Subject: **Bid No. 7682-W2, Hospital Drive Construction – Phase II (M21-10) / DPWP**

### **ADDENDUM NO. 2**

Project: Creation of Hospital Drive (M21-10) – Bid No. 7682-W2  
City of Worcester Department of Public Works and Parks  
DPW&P – Engineering Division

**Bid Question Responses Submitted as of End of Day 11/12/2021**

PROJECT TITLE:  
ELECTRICAL  
SITE LIGHTING  
PLAN 1

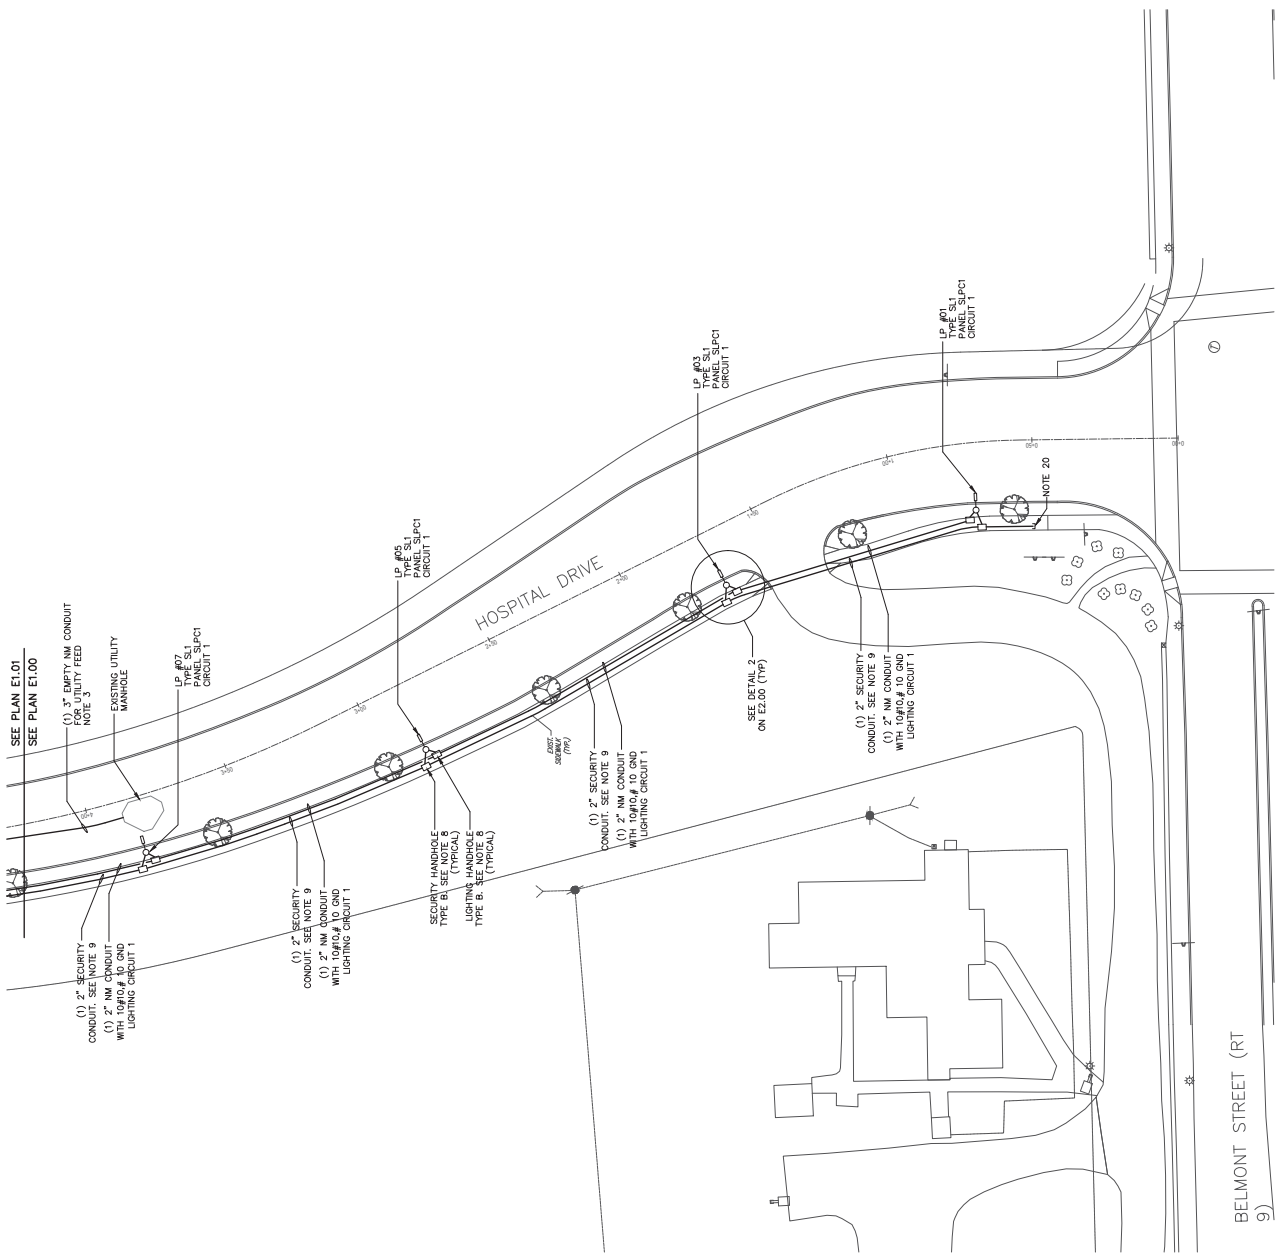
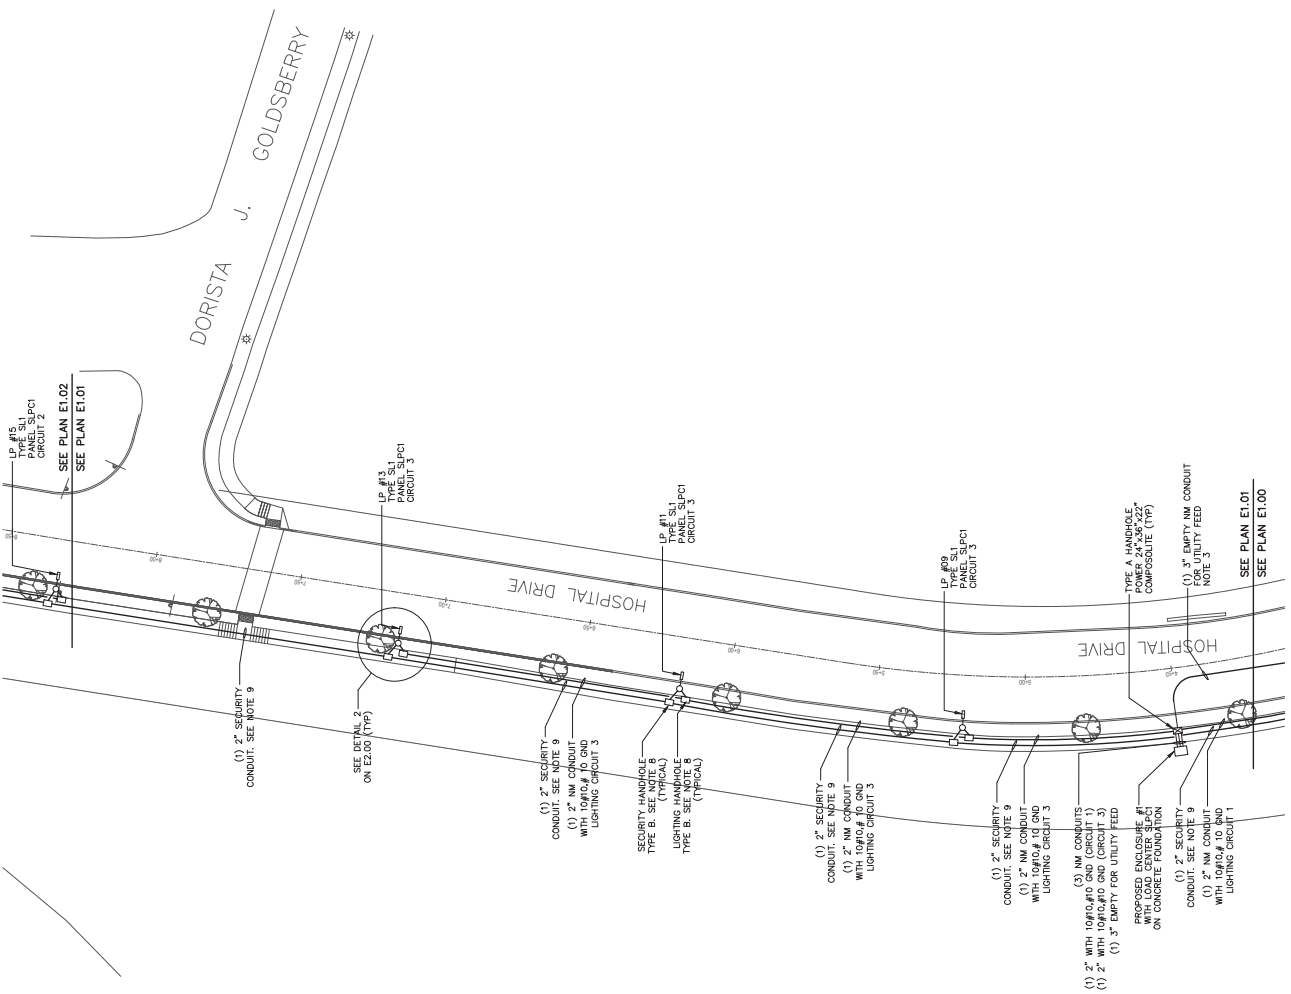
- 44- Plans reference plans by Wozny Barbar in several locations for lighting info-please provide these plans.  
*The requested plans have been included with this addendum.*

- 45- On plan sheet 9, a note calls for 2 each-2" lighting conduits and handholes at Station 0+75 left (the same note is on plan sheet 10 around station 6+25, Left). The line then seems to split with conduit going to a handhole and branching to another handhole. Will both handholes have 2 each-2" conduits into and out of them? If so, the main run should have 4 Each-2" conduits for them to branch out. Please clarify. (perhaps the Wozny Barbar plans will clear this up).  
*Please refer to the provided Wozny Barbar plans.*
